AMENDMENT OF SOLICITATION/MODIFICATION OF CONTRACT			1. CONTRACT ID CODE	PAGE 1 OF 6 PAGES
2. AMENDMENT/MODIFICATION NO. AMENDMENT NO. 0002		3. EFFECTIVE DATE 08/27/14	4. REQUISITION/PURCHASE REQ. NO.	5. PROJECT NO. (If applicable) 14-0090
6. ISSUED BY CODE		mks	7. ADMINISTERED BY (If other than Item 6) CODE See Item 6	
Officer in Charge of Construction MCI-East 1005 Michael Road Camp Lejeune, NC 28547-2521				
8. NAME AND ADDRESS OF CONTRACTOR (No., street, county, State and ZIP Code)			(X)	9A. AMENDMENT OF SOLICITATION NO. N40085-14-R-0090
			X	9B. DATED (SEE ITEM 11) 08/20/14
				10A. MODIFICATION OF CONTRACT/ORDER NO.
				10B. DATED (SEE ITEM 11)
CODE	FACILITY CODE

14-0090 Interior/Exterior Repairs, Building FC120

Incorporate revised sheets FA-1, FA-2, FP-1, and FP-2 into the project/contract.

FA-2

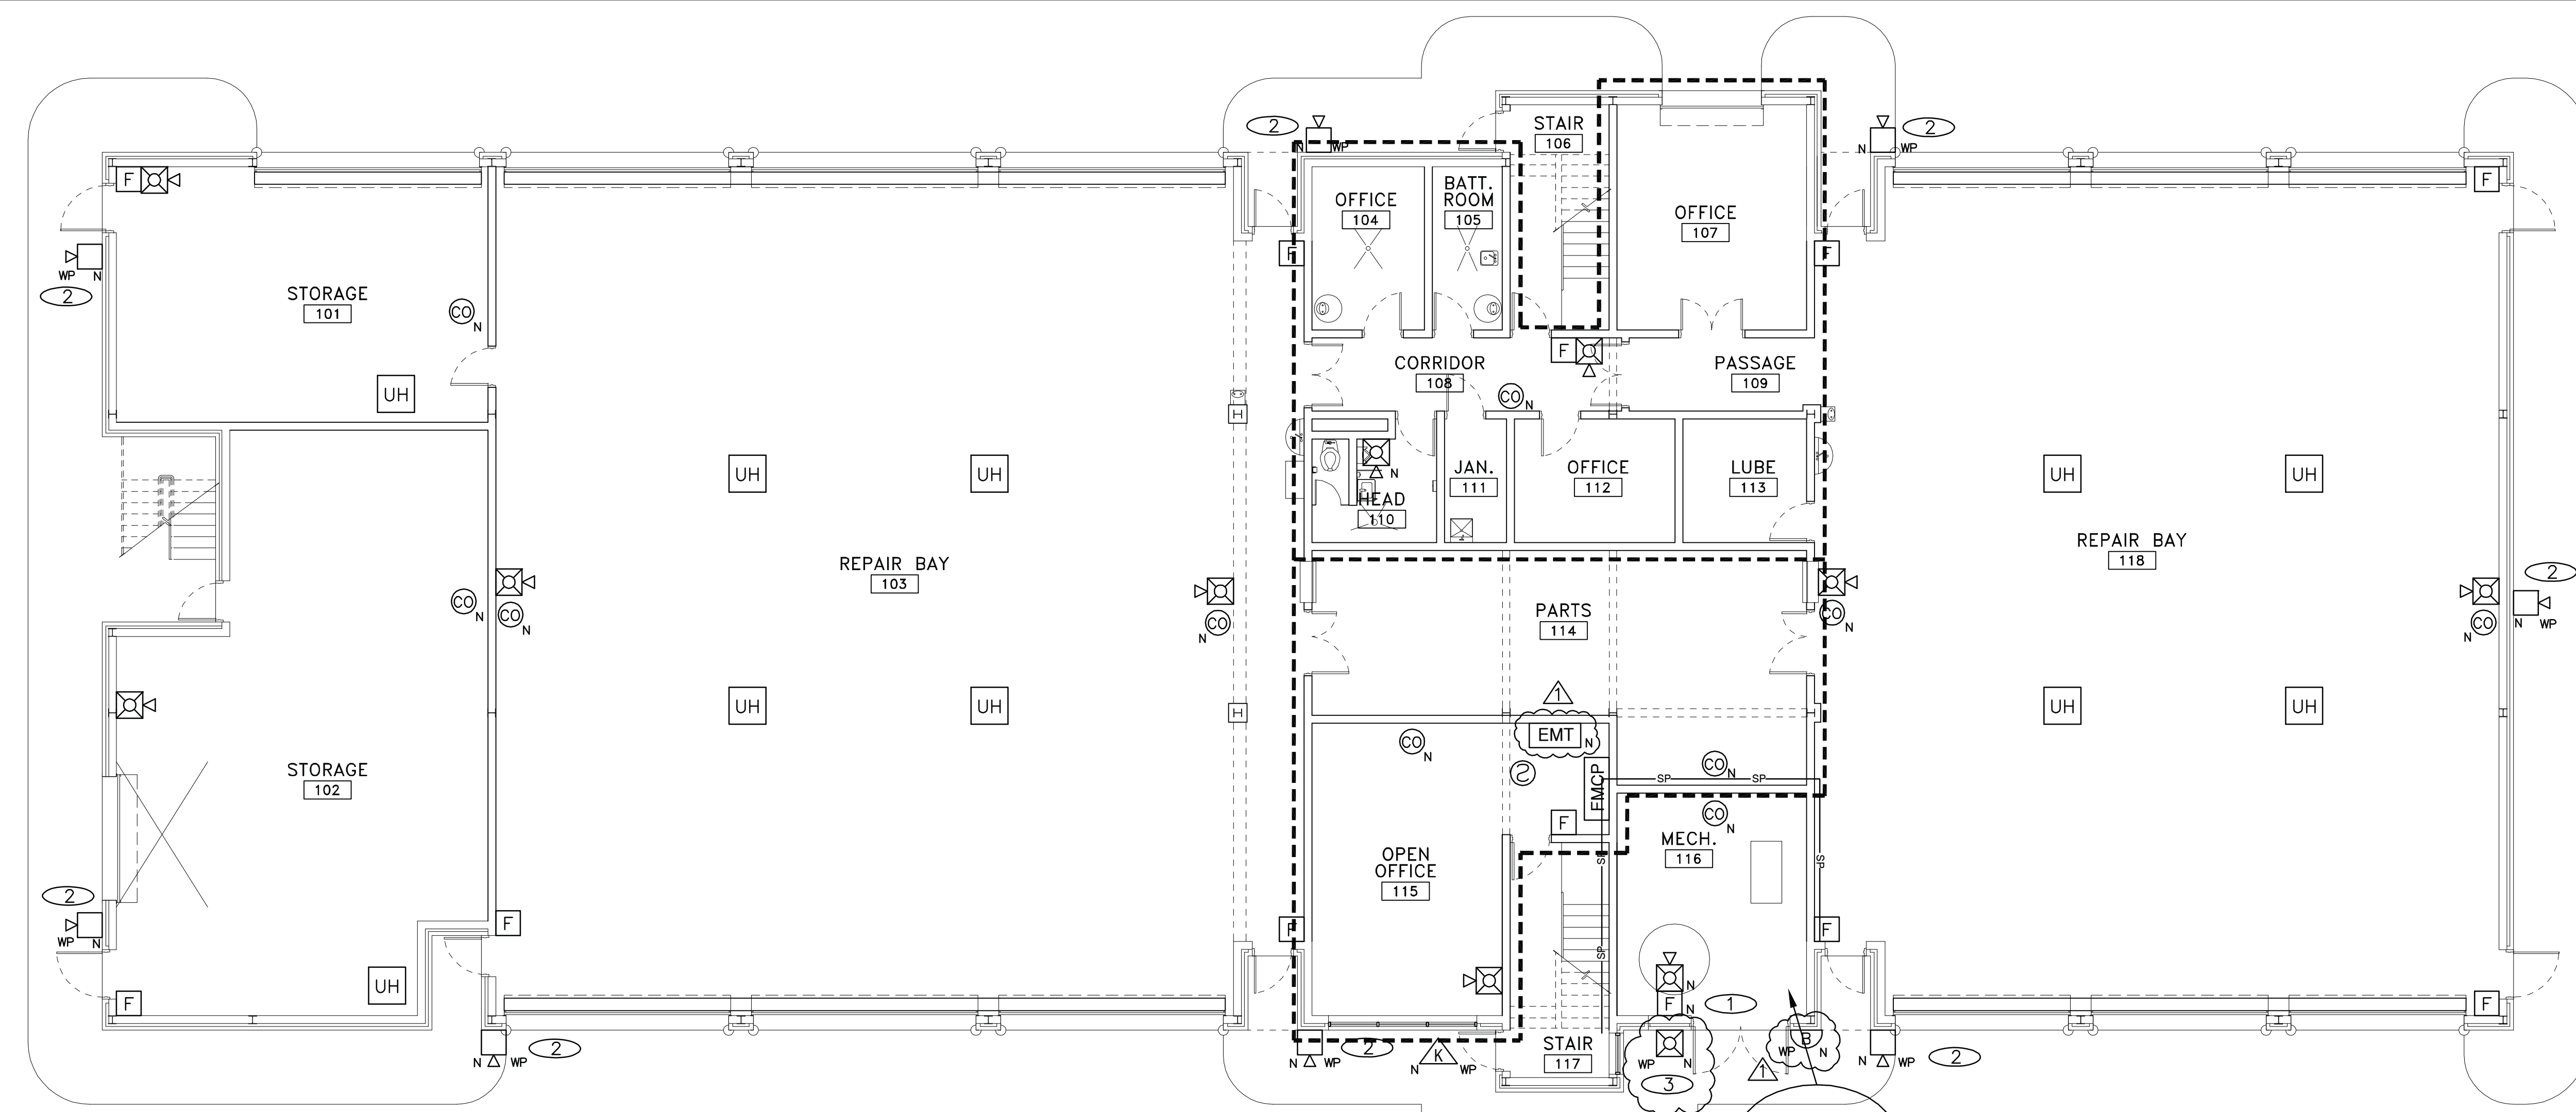
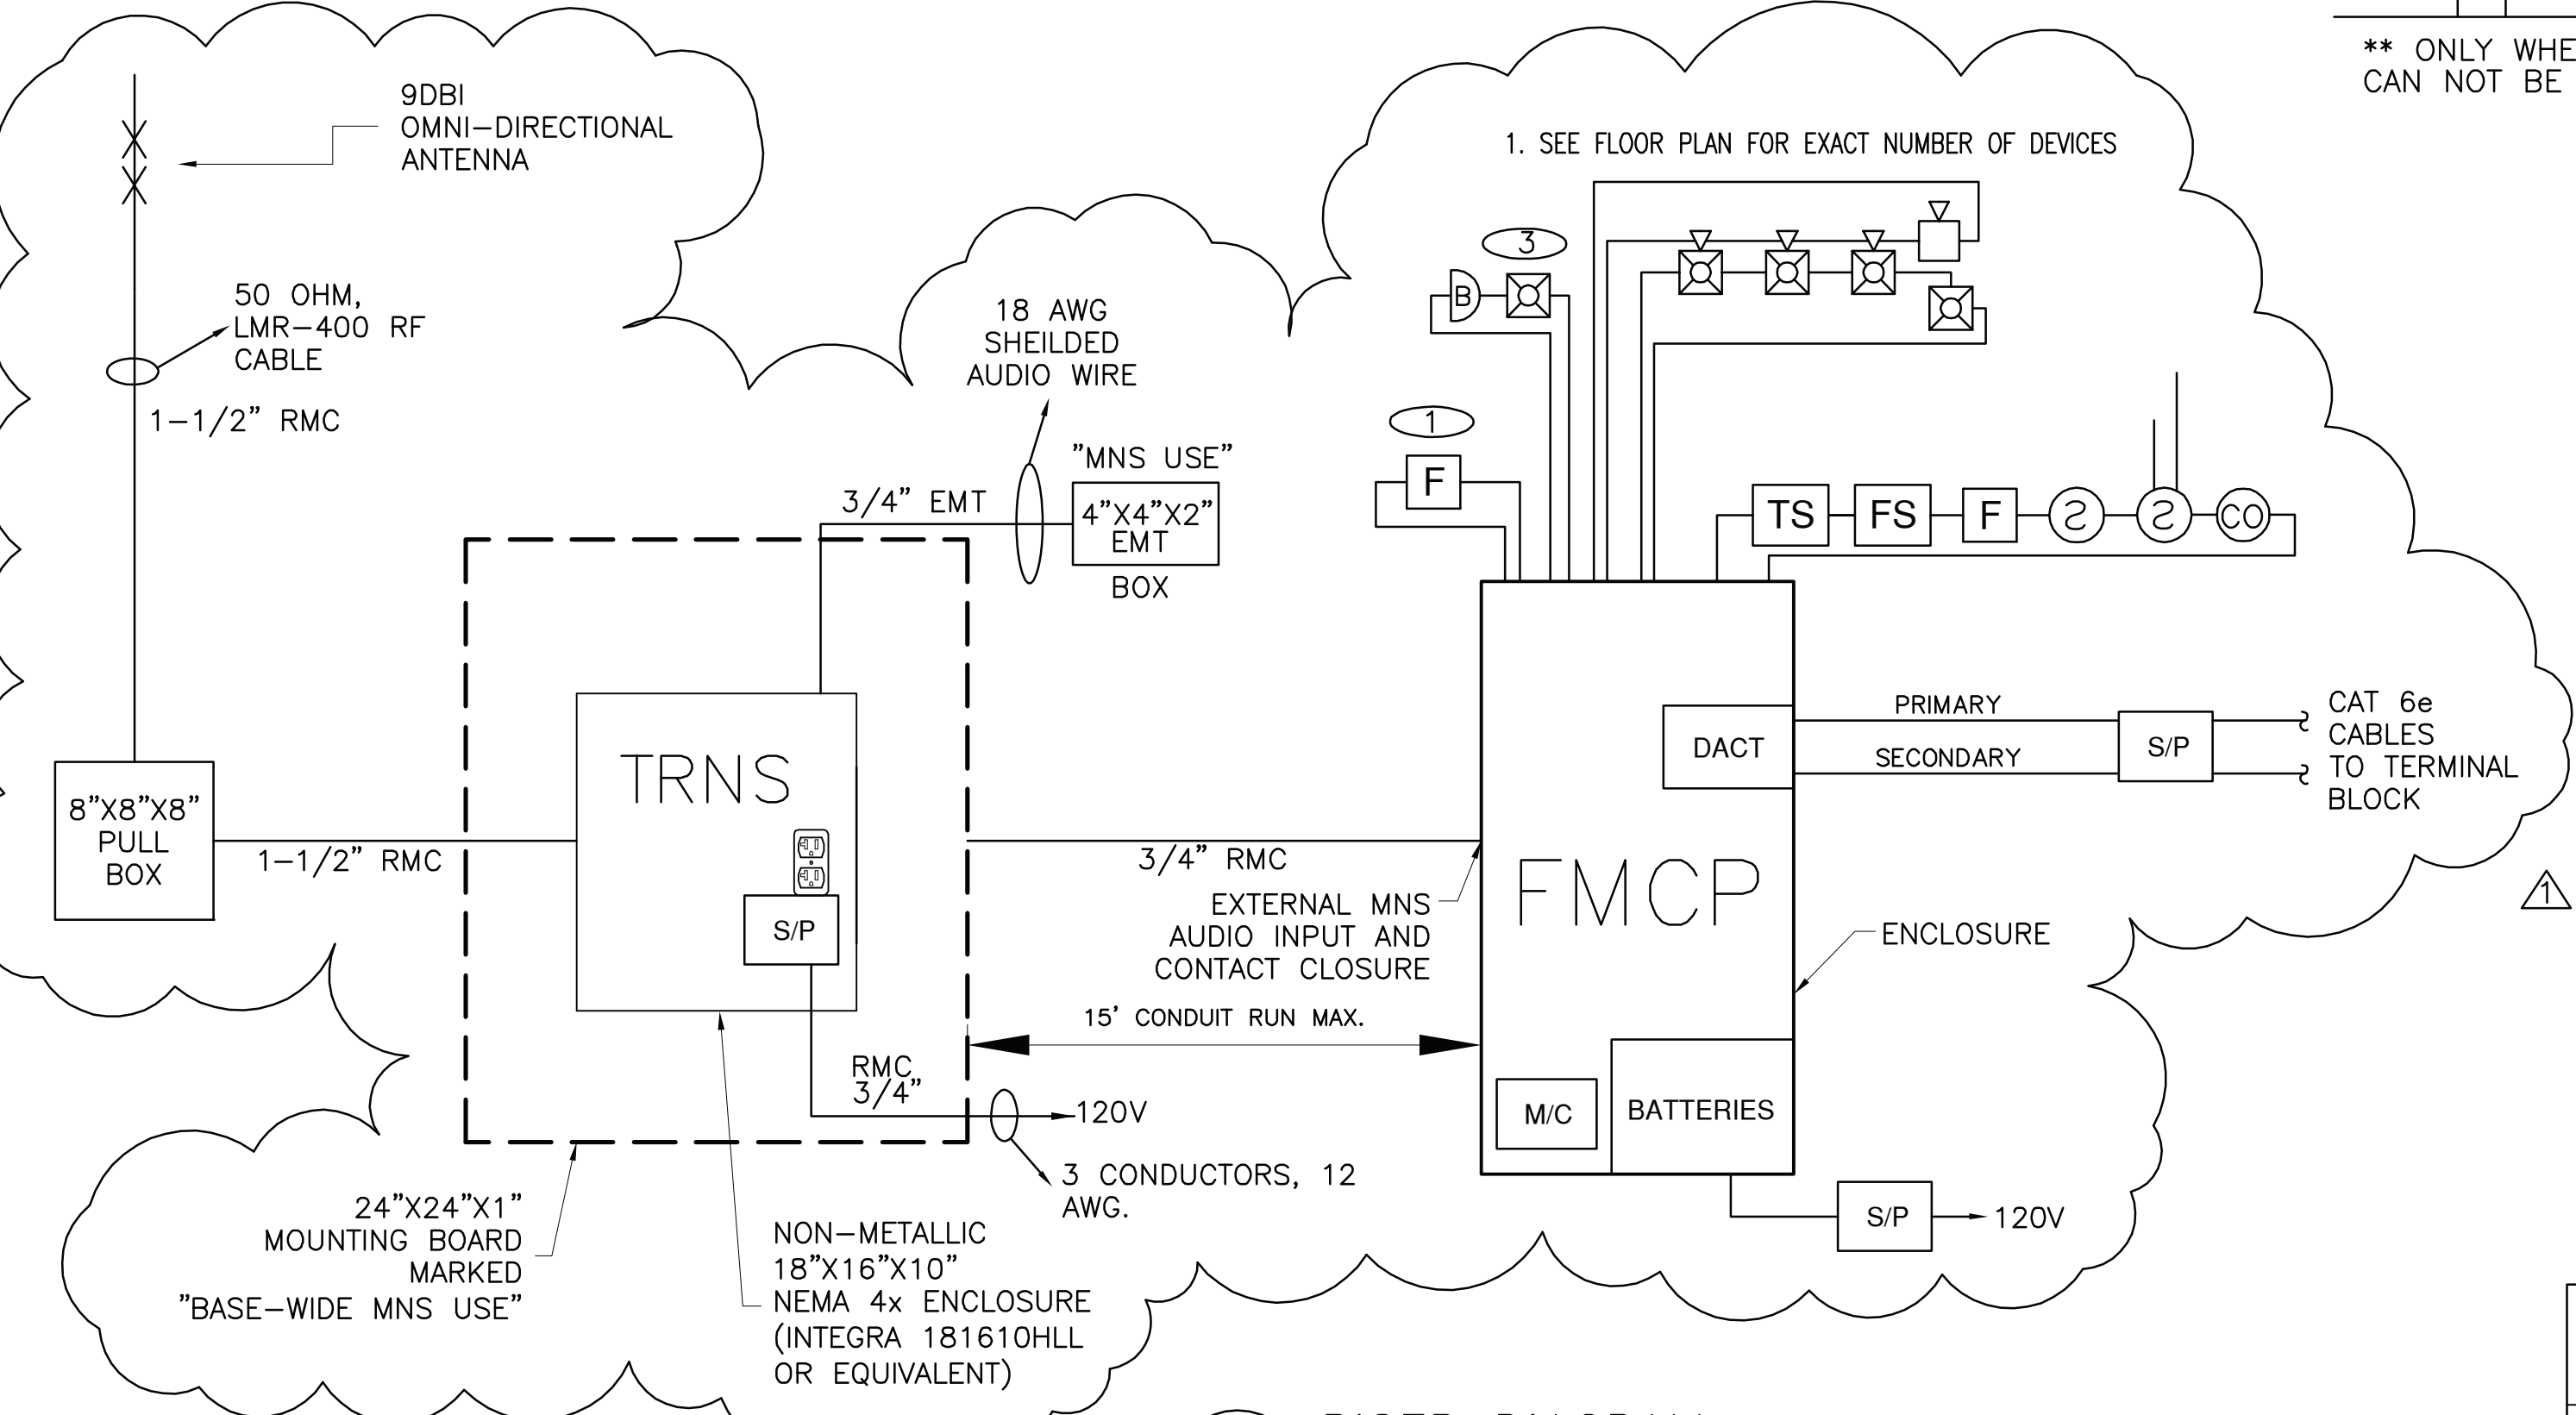
1. FA-2: Provide/install a fire alarm pull station in Storage room 102 on west wall adjacent to the door leading to stairwell.
2. FA-2: Provide/install a speaker strobe in room 114 on west wall adjacent to door.
3. FA-2: Provide/install a FAD beside the new FMCP.
4. FA-2: Provide/install a speaker strobe in room 107 on east wall.
5. FP-2: New Wet Pipe Riser-Omit the Alarm Check Valve and replace with a Flow Switch.
